## **ADDENDUM #2**

Date: May 14, 2015

**ADDITION & REMODEL  
KENWORTH SALES - JEROME  
JEROME, IDAHO**

**C1.00**

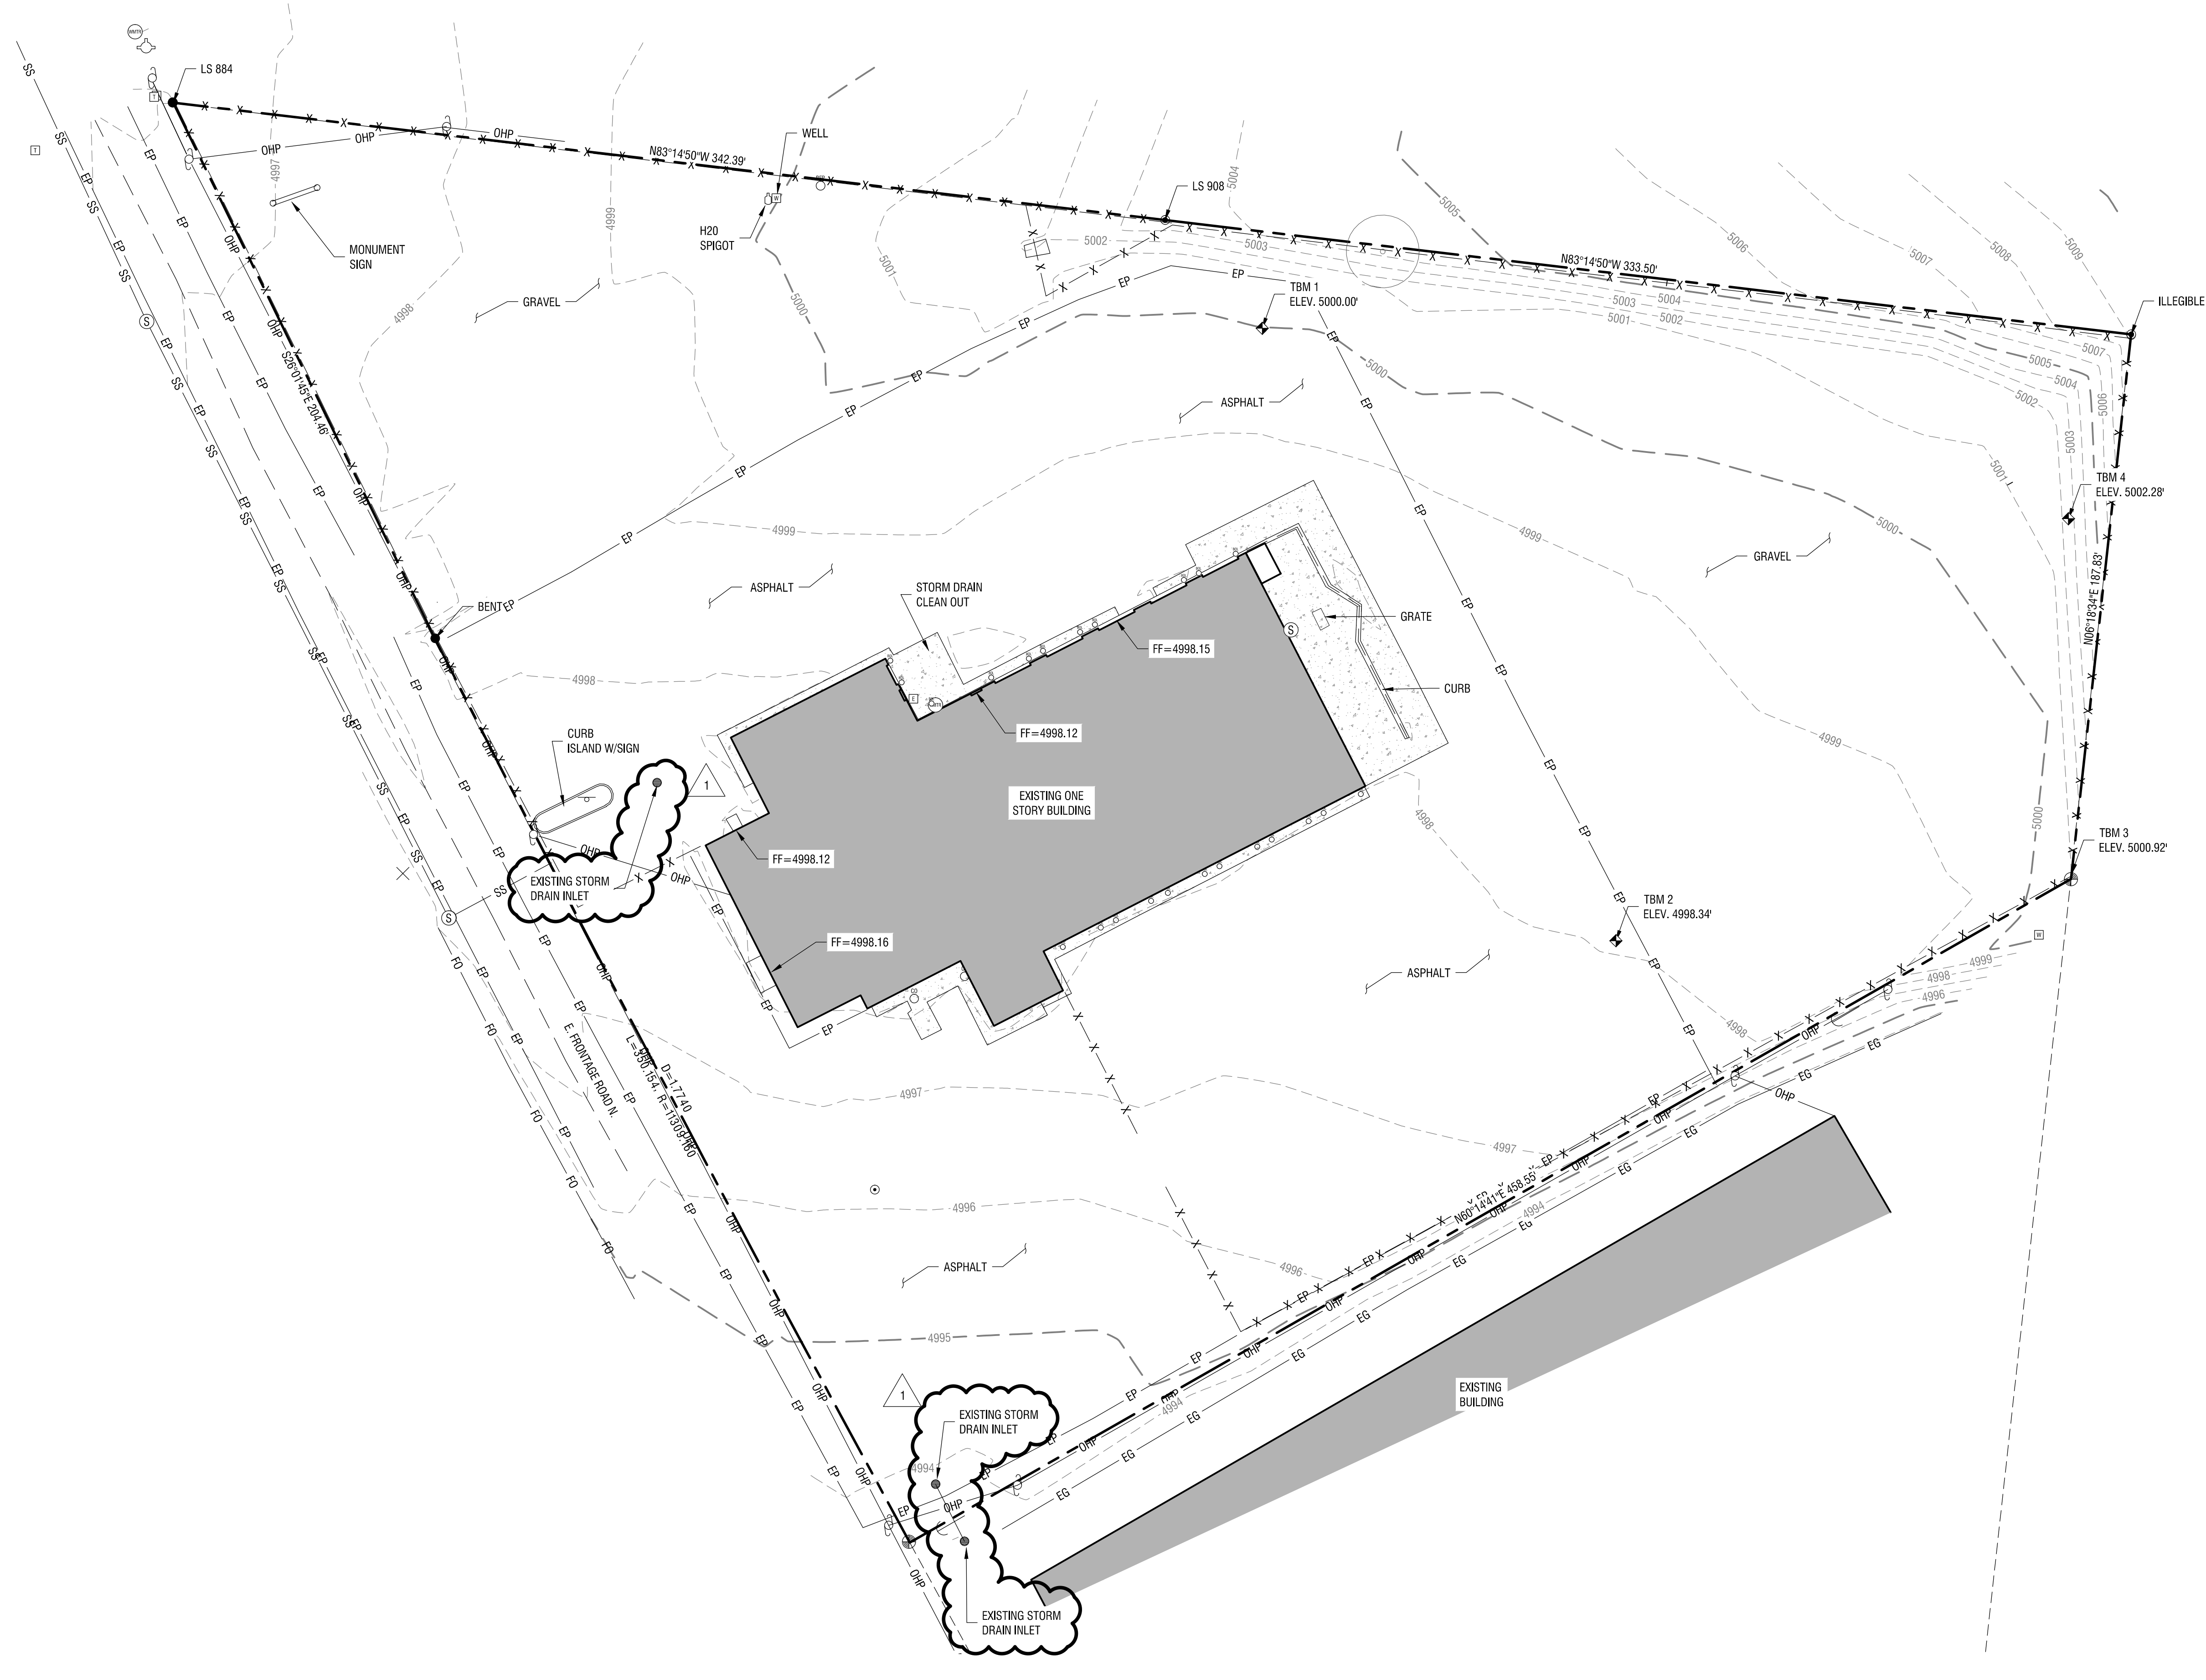
- 1.0 **SHEET C1.00 – Existing Site Topography**  
CORRECTION: **Corrected** miss-spelled “Strom Drain” to “Storm Drain”.
- 1.1 **SHEET C3.00 – Construction Notes**  
REVISION: **Revised** general note 21 and added note 22.
- 1.2 **SHEET C4.00 – Site Grading Plan**  
REVISION: **Revised** plan to provide an asphalt swale to direct storm drain runoff to the inlet at the south west corner of the site.

# MEZZANINE PLAN

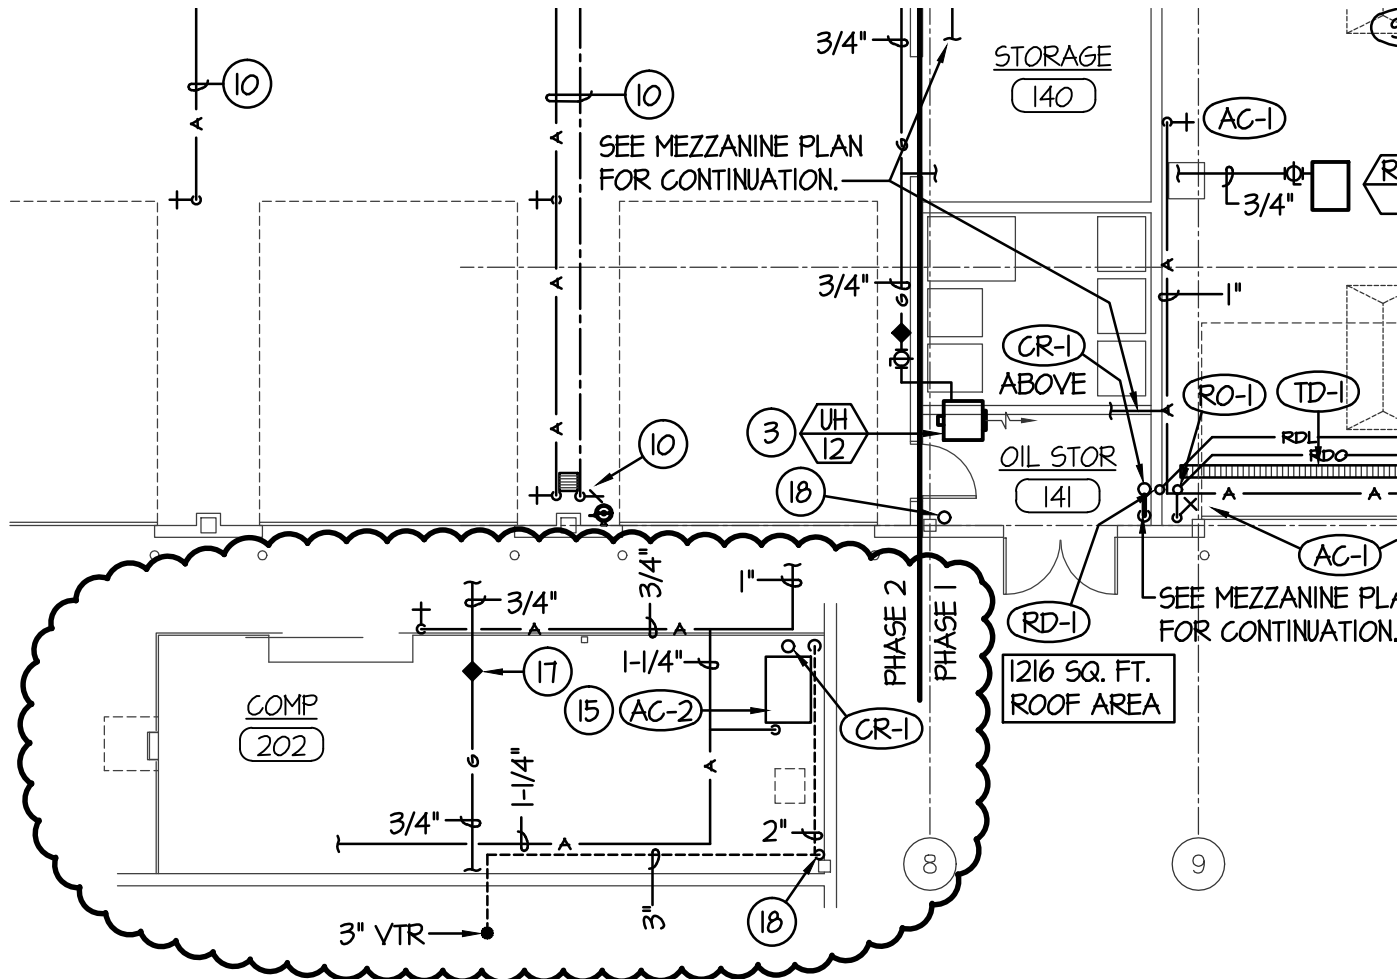
- v. See revised Mezzanine Mechanical plan attached.
  - b. Sheet M3.1.
    - i. Rooftop HVAC Unit Schedule- RT-5 shall be Titan Model TA-115NGHRD w/EV.

# MEZZANINE PLAN

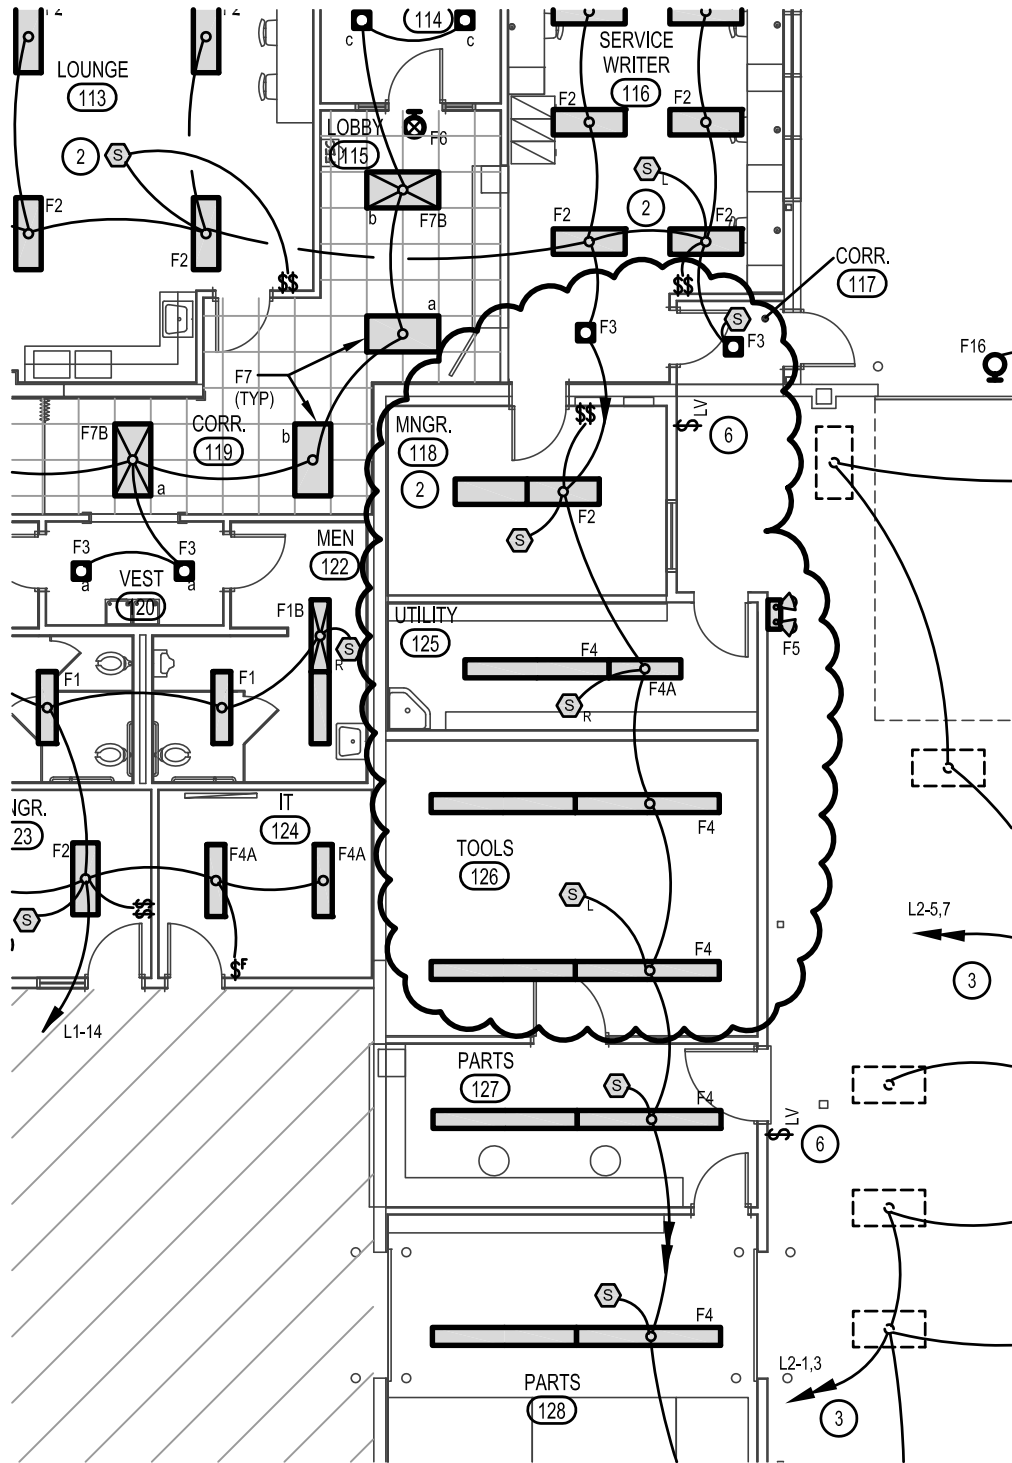
- ii. See revised Mezzanine Plumbing plan attached.
2. Specifications:
  - a. Section 23 5416 2.1.C: Units shall be equipped for natural gas and 120V 1 phase.
